GEOENGINEERS

Subject: Response to City of Portland BDS Site Development Checksheet dated November 5, 2019
Prologis Development at NE 158th Avenue and NE Airport Way
Portland, Oregon
File No. 3626-071-00

Figure 1. Revised Building and Preload Fill Footprint
Field Report 26 - 9/12/2019
Field Report 27 - 9/13/2019

1.1

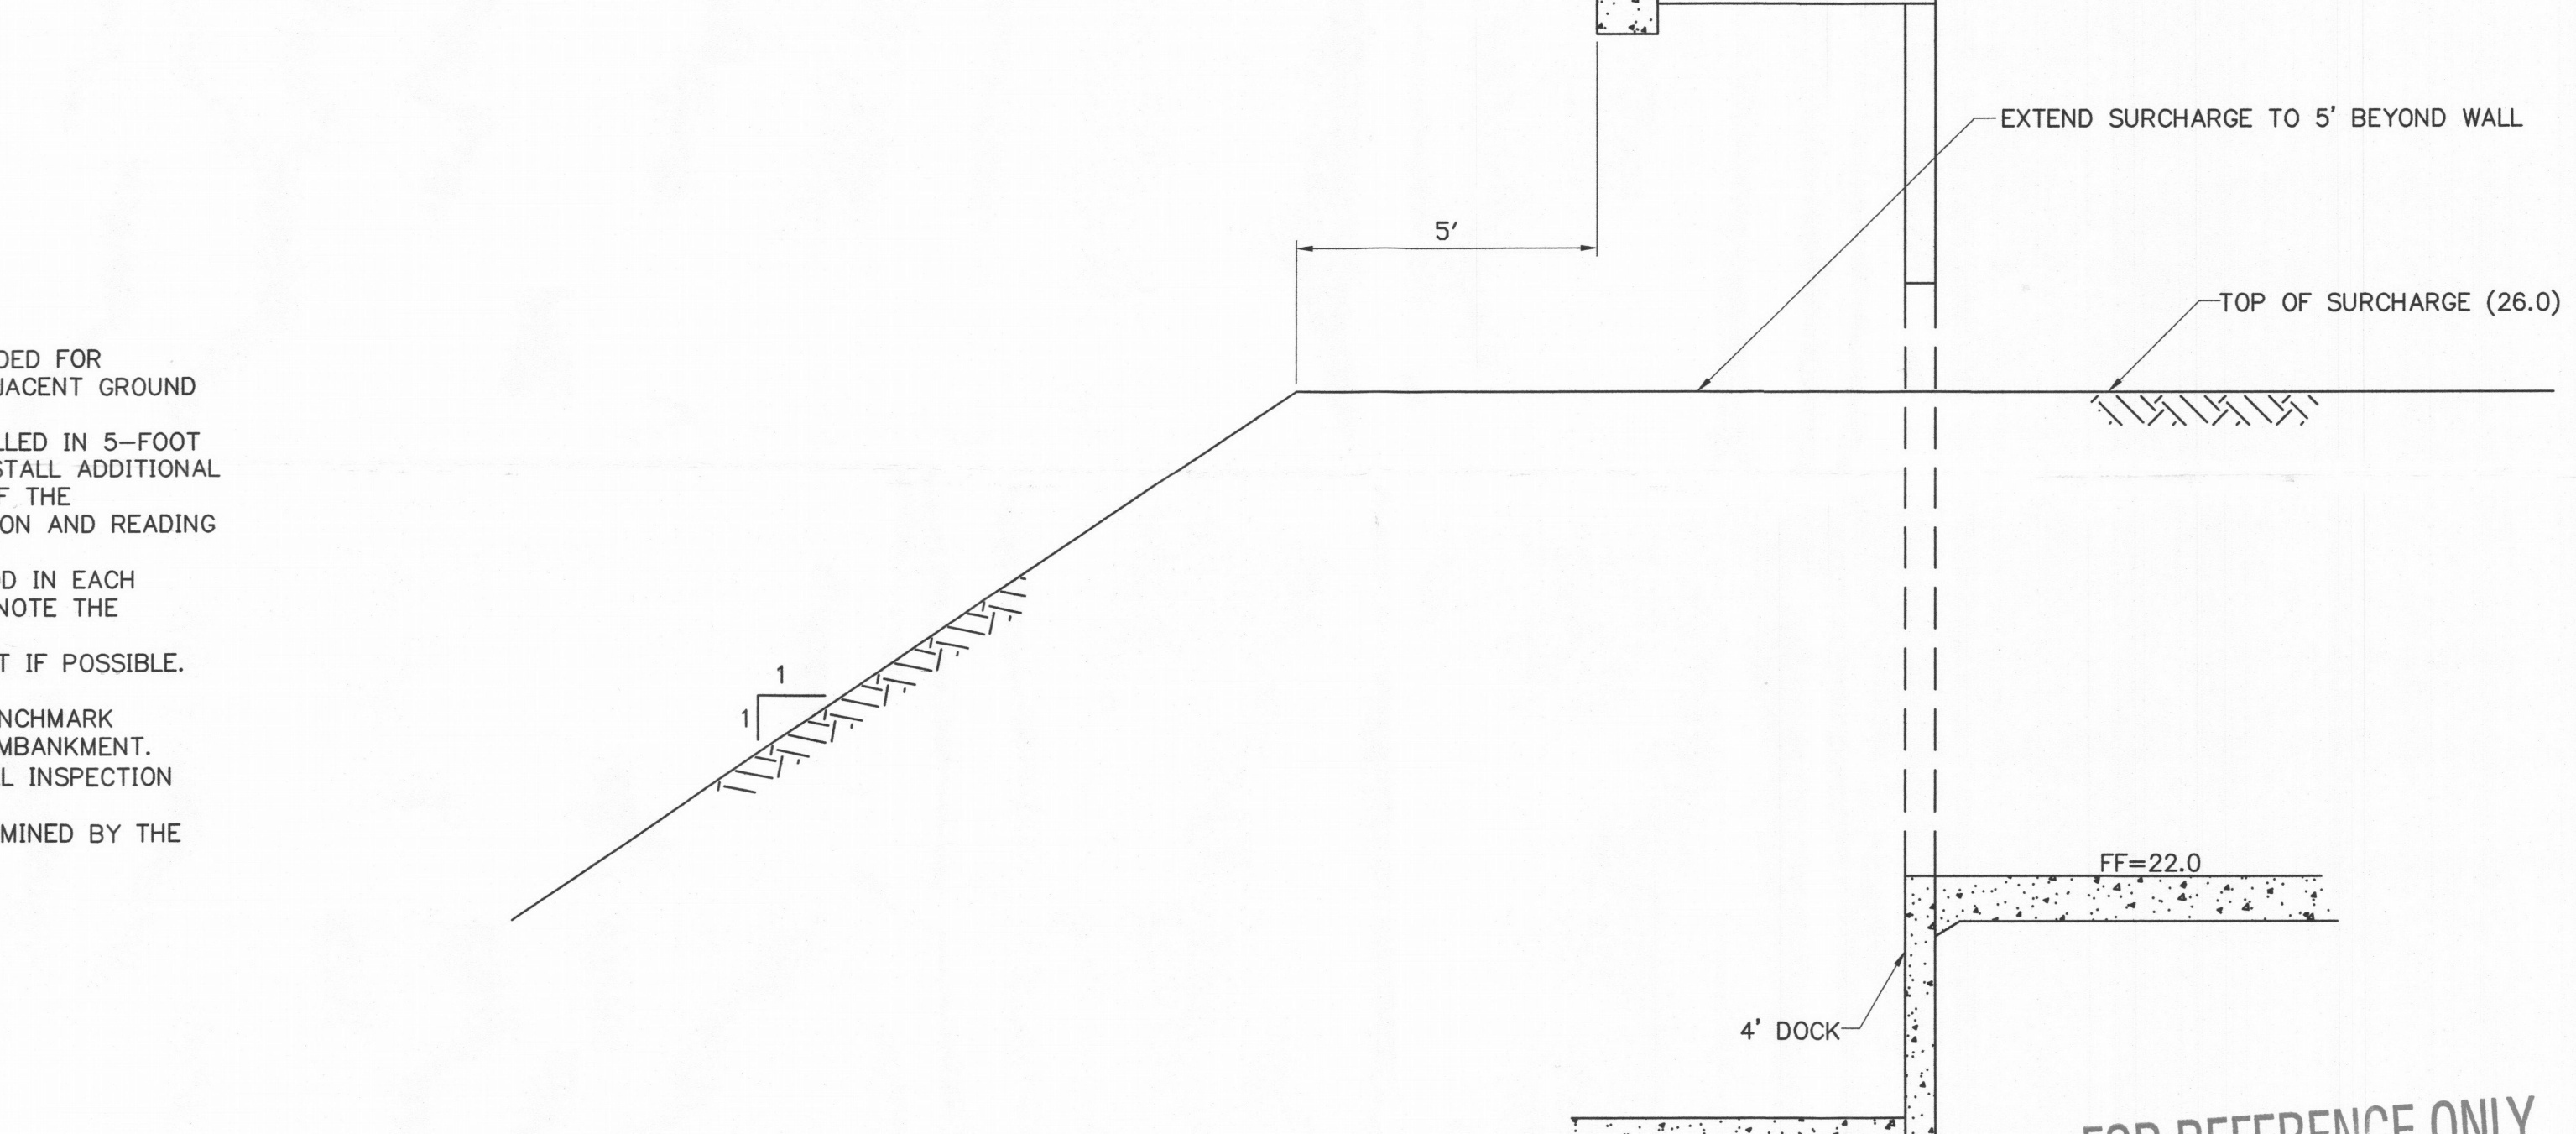
This letter respond to the checksheet correction items 1 and 2 provided by City of Portland Bureau of Development Services dated November 5, 2019. This letter is to acknowledge that GeoEngineers was aware of the revision to the proposed building footprint. We provided revised preload recommendations, and observed and evaluated the preload fill placed within the revised building footprint.

We understand that the proposed building at the site has been relocated approximately 16 feet west of its original location. Figure 1 presents the revised building footprint and the revised preload fill footprint constructed per our recommendations. We also completed two site visits to observe the preload fill placement within the revised building area west of the original building footprint. Our observations of the preload fill placement and evaluation are presented in the attached Field Reports 26 and 27, dated September 12 and 13, 2019, respectively. The settlement monitoring program developed and implemented for this project incorporated the revised footprint and therefore no updated preload summary letter is required.
